10.2 Approval for Coldwell Banker to Enter into an Agreement with Sisk Enterprises for Earthquake Repairs at Sierra Vista Education Center Units 1305-1317

Client: Amary Youso
Project Name: Coldwell Banker – Ridgecrest
AED Project No: 19084
Revision: A
Date: October 3, 2019

SECOND STRUCTURAL OBSERVATION REPORT

Photo H - Inter-connecting breezeway

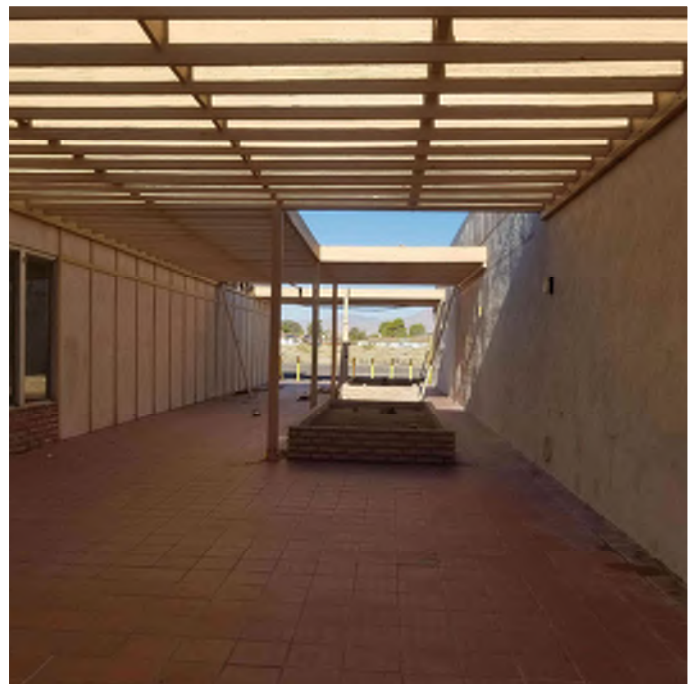
1. Facade has numerous cracks; some have been repaired and some have not. (See photos I-L)
2. Inter-connecting breezeways beams have shifted and show signs of dry rot. (See photo H)
3. Cracks in the stucco at the rear of the building. (See photo M)
4. Eastern wall pulled away from main building and partially collapsed the roof. (See photos N-Q)
5. Front covered walkway framing members and connections show signs of movement. (See photos R-T)

1. Building Façade - Contractor to expose framing behind façade for more in depth investigation during second site visit.
2. Inter-connecting breezeways - Contractor to remove and replace in-kind all rotted beams, joist, ledgers, etc.

Photo N - Eastern wall leaning away from building

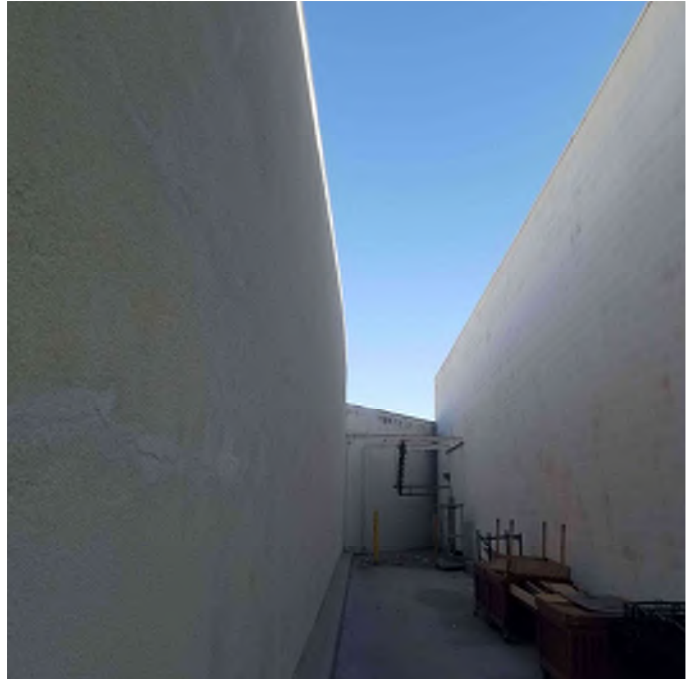
3. Rear Walls - Contractor to expose framing behind stucco for more in depth investigation during second site visit.
4. Leaning wall and collapsed roof – Contractor to remove some of the ceiling to better expose the connections at the beams to wall connections. This should be established at a couple locations with in the building. Contractor should also expose other locations if possible, like at interior columns, interior separation walls between suites, etc. This would help in the assessment of the existing structure.

Photo 1

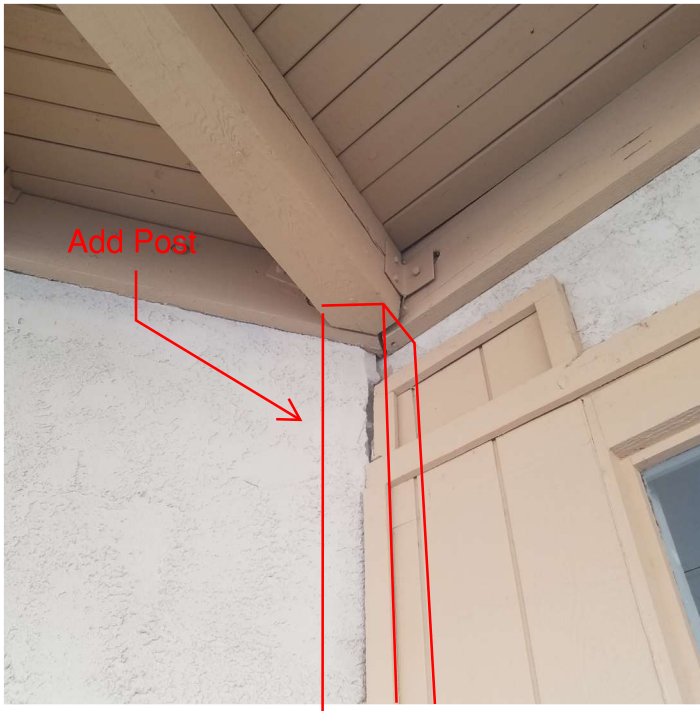
1. Building Façade: There are a number of issues with the building façade.
 - a. Suggestion: Add a post beneath the roof beam where the beam has slightly pulled away from the wall. See photos 1 & 2. Connection details will need to be provided by a licensed engineer.

Photo 11

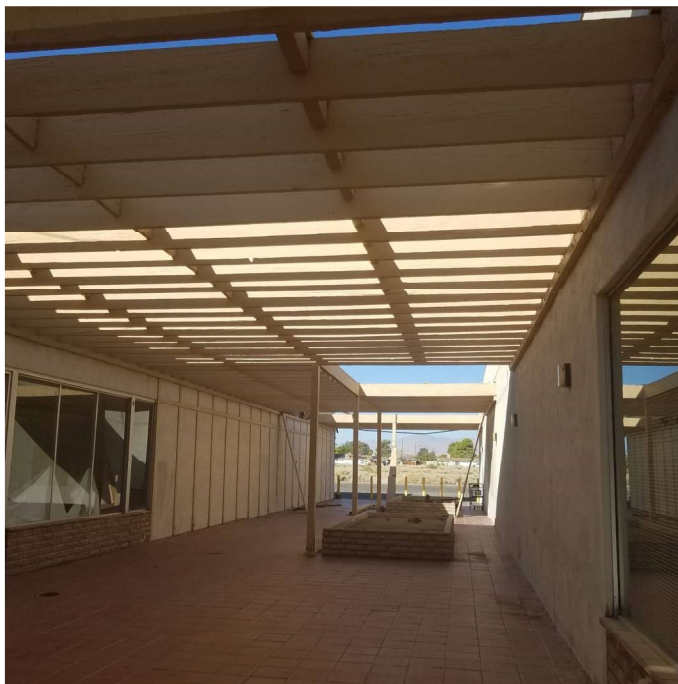
- a. Suggestion: Remove all structural items that connect the three building. See Photos 9 thru 13. This would include removing the lattes, beams, and parapet. Demolition details should be prepared by a licensed engineer.
